ORIGINATION FORM

Proposed Revisions to a Standard Plans Index
(Please provide all information — Incomplete forms will be returned)

Index Number: 102-604
Sheet Number (s): 1 and 2 of 2
Index Title: Two-Lane, Two-Way, Intersection Work

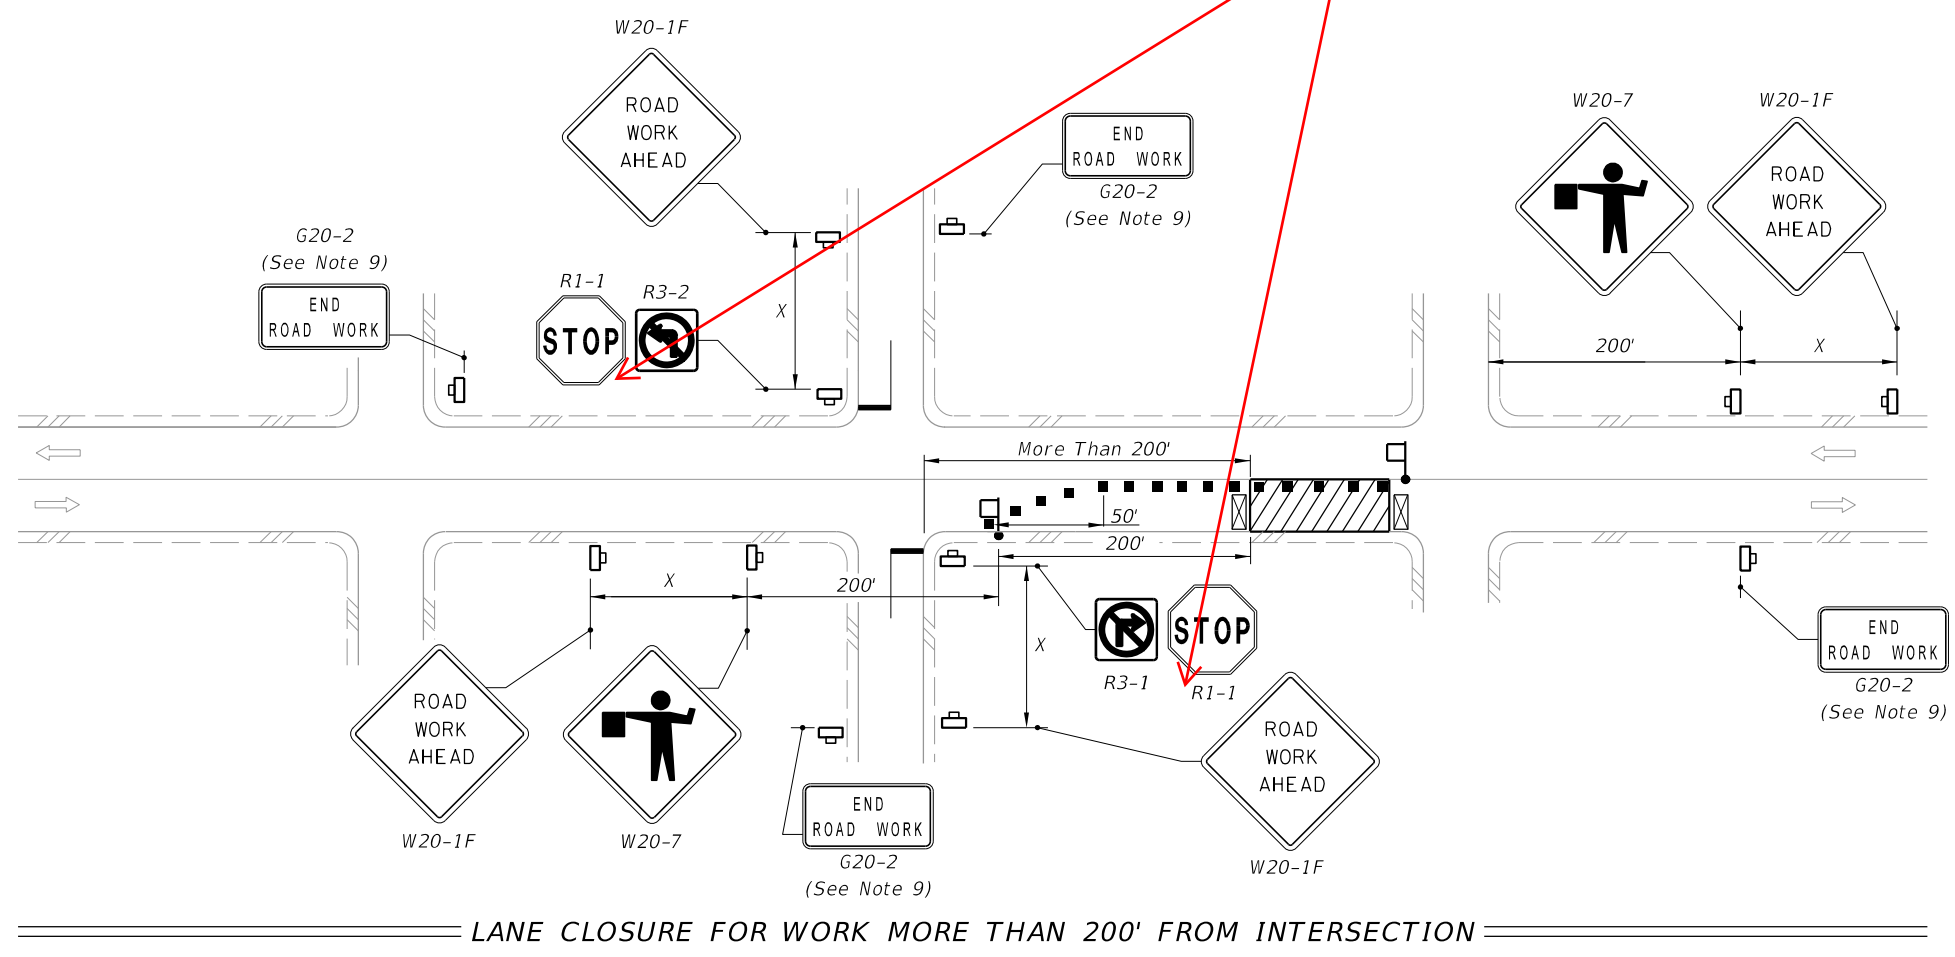
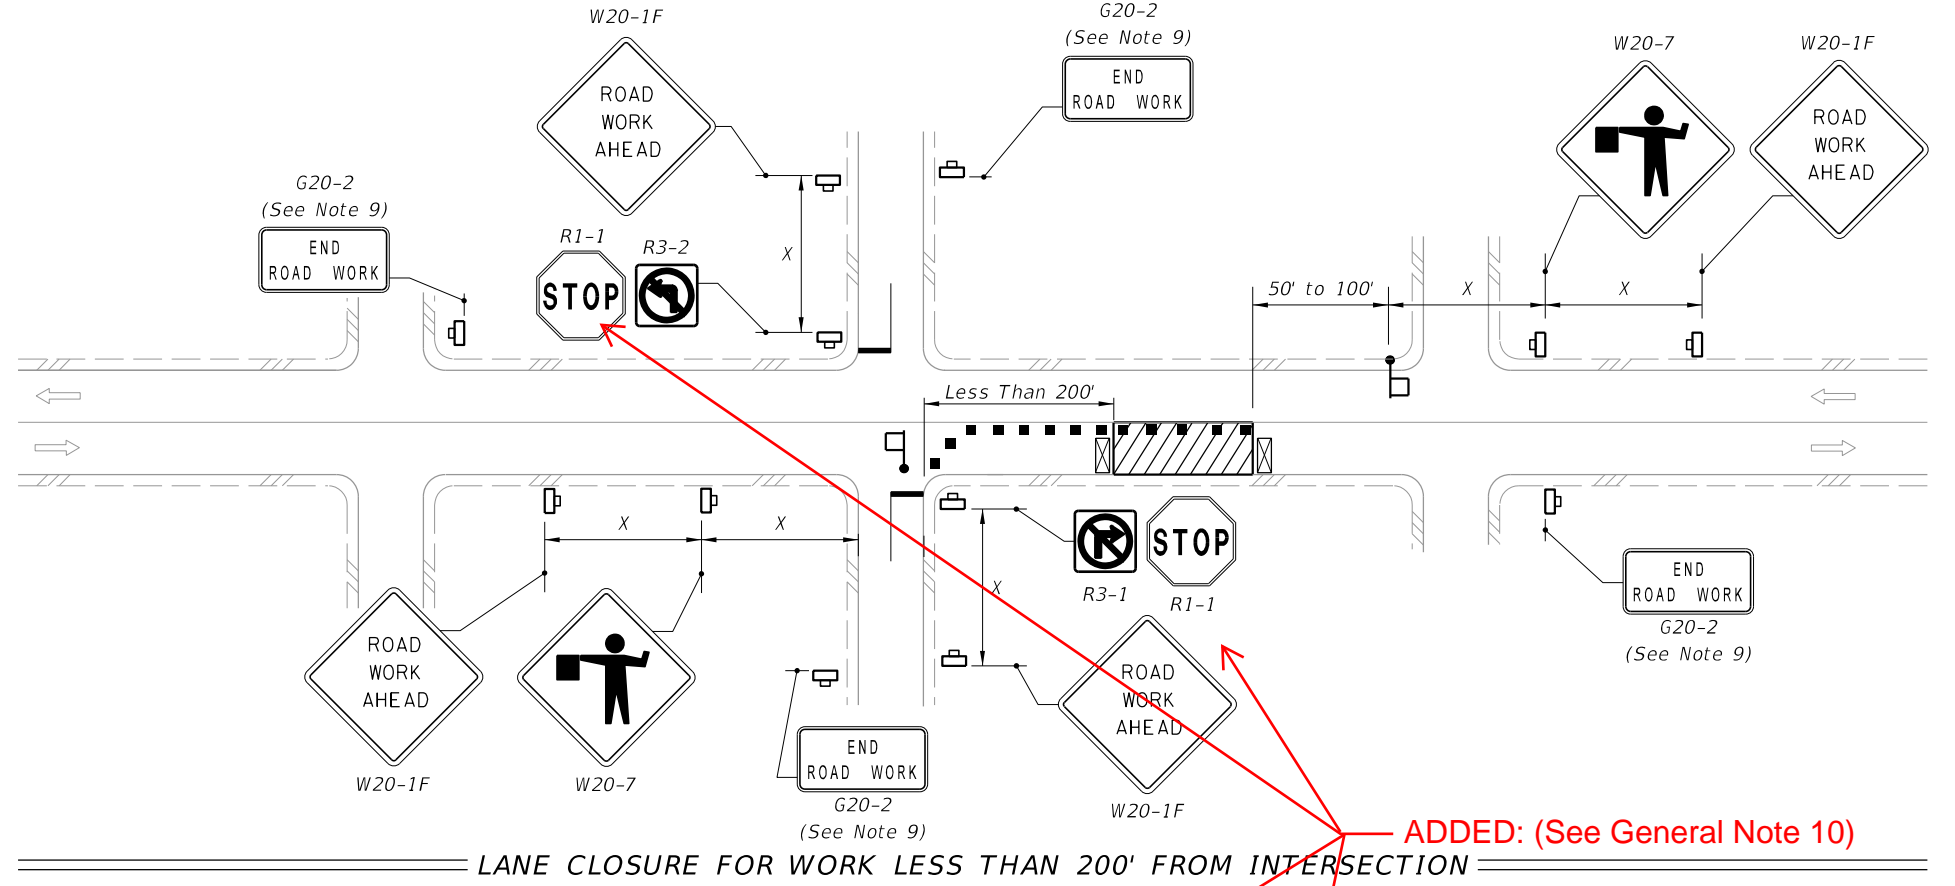
Sheet 1: Changed Note 9 - "ridable shoulder" to "4' or greater paved Shoulder"; Added General Note 10: Added (See General Note 10) at intersections with R1-1 and R3-2 signage.

10. **CHANGED TO: 4' or greater paved**
ADDED: Note 10
Optionally, See Index 102-600 for side road flagging operation instead of turn restriction signage.

ADDED: (See General Note 10)

WORK IN INTERSECTION OF TWO-LANE ROADWAY

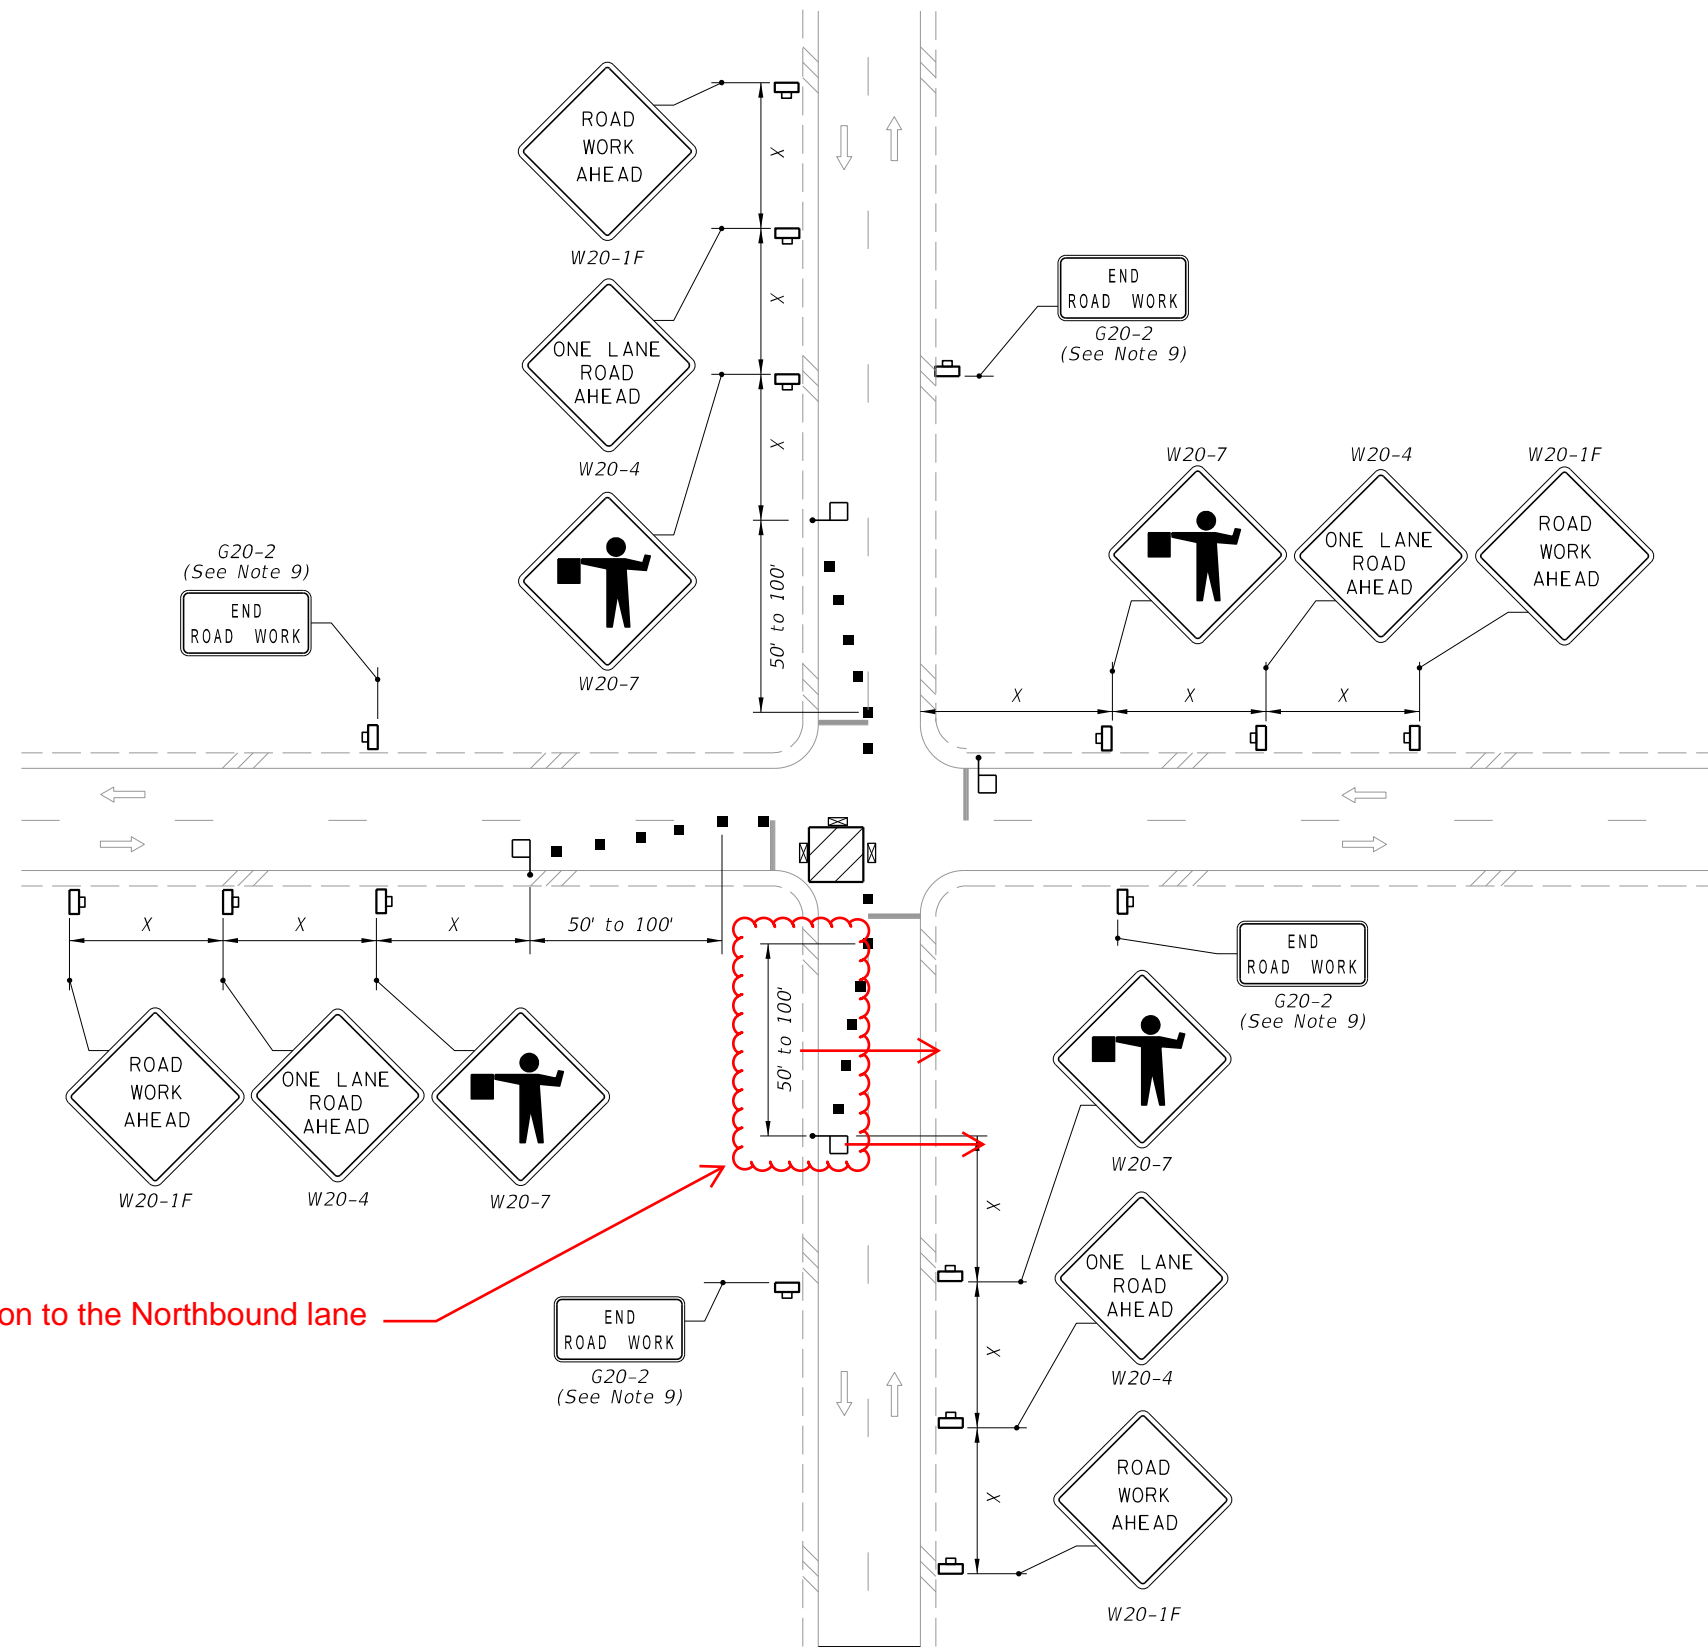
Sheet 2: Moved the Flagger and associated dimension on the Southern lanes of the detail, from the southbound lane to the northbound lane.

MOVED: Flagger and Dimension to the Northbound lane
